Mitchell/April Womack Old Buies Creek Rd Buies Creek, NC

SHEET 2

DESCRIPTION: FOUNDATION PLAN

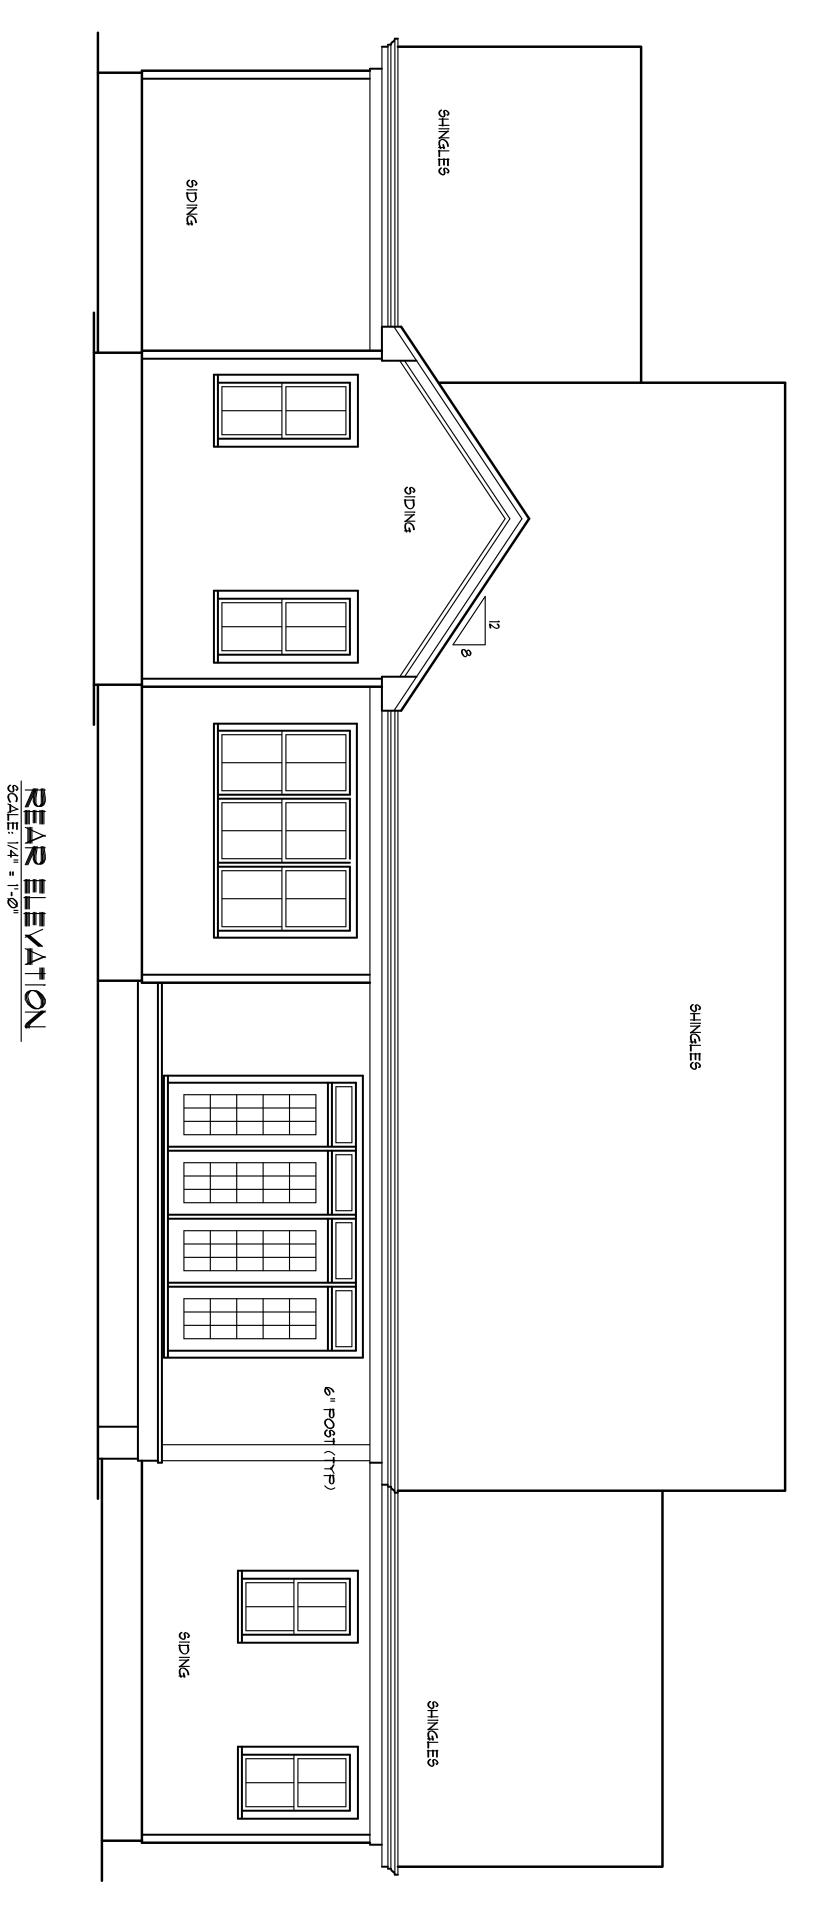
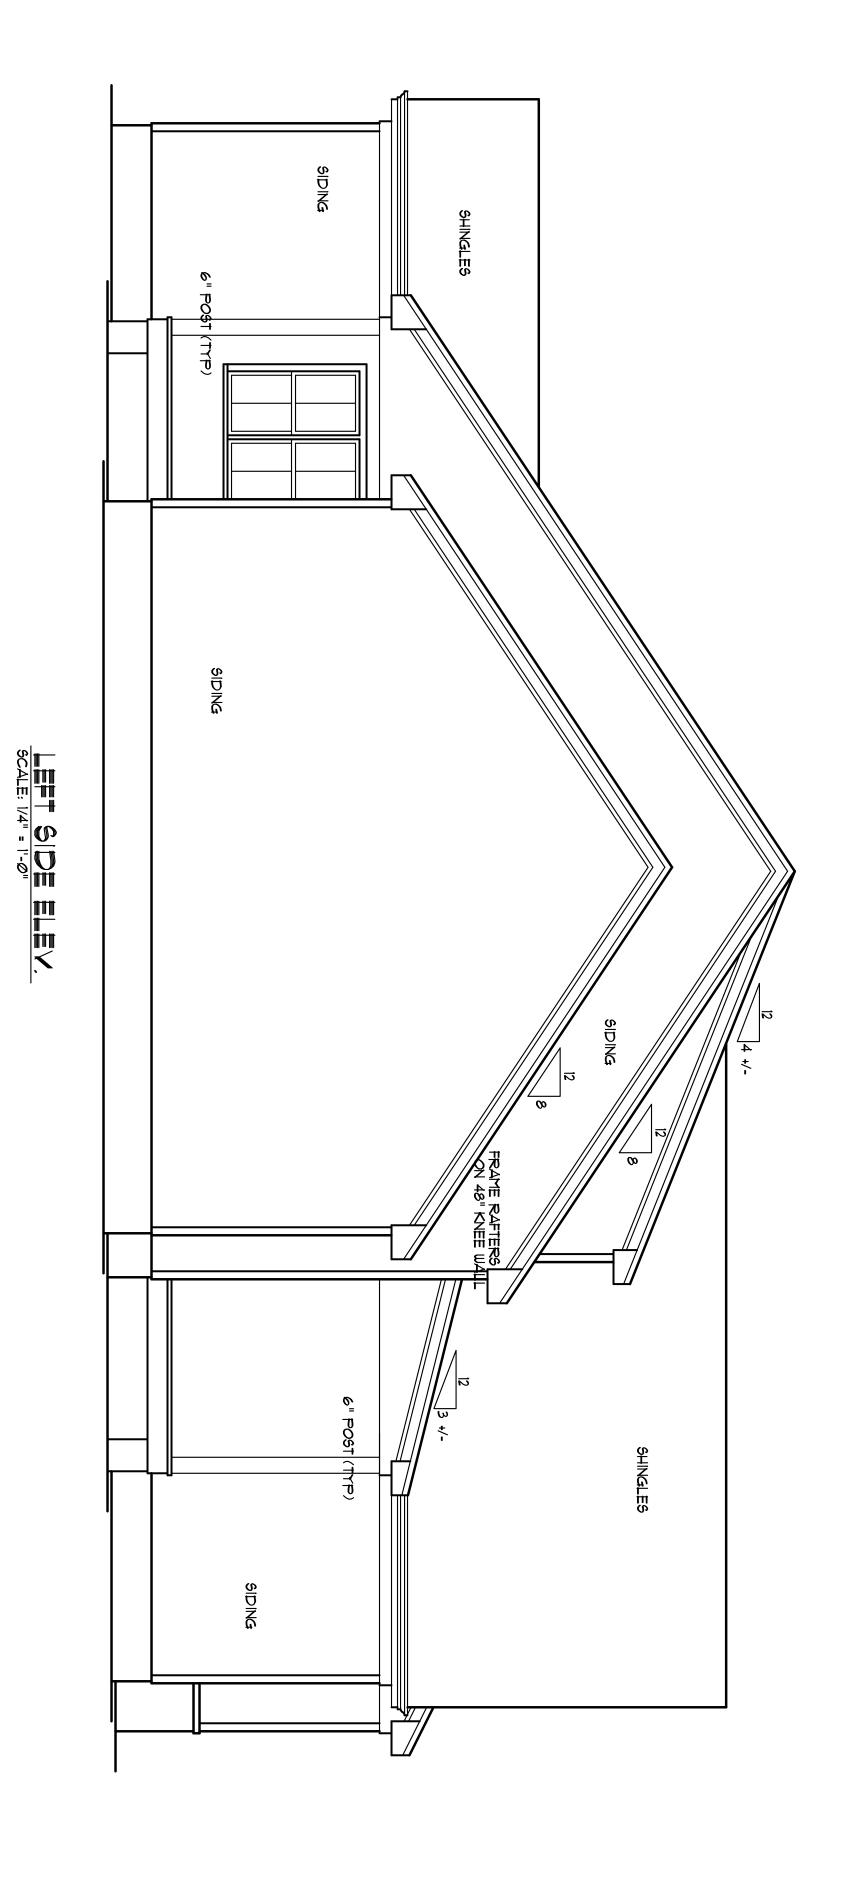
Field verify egress window sizing. Typically, double hung 4/6 windows will not open to the minimum height required by NCRC 2018.
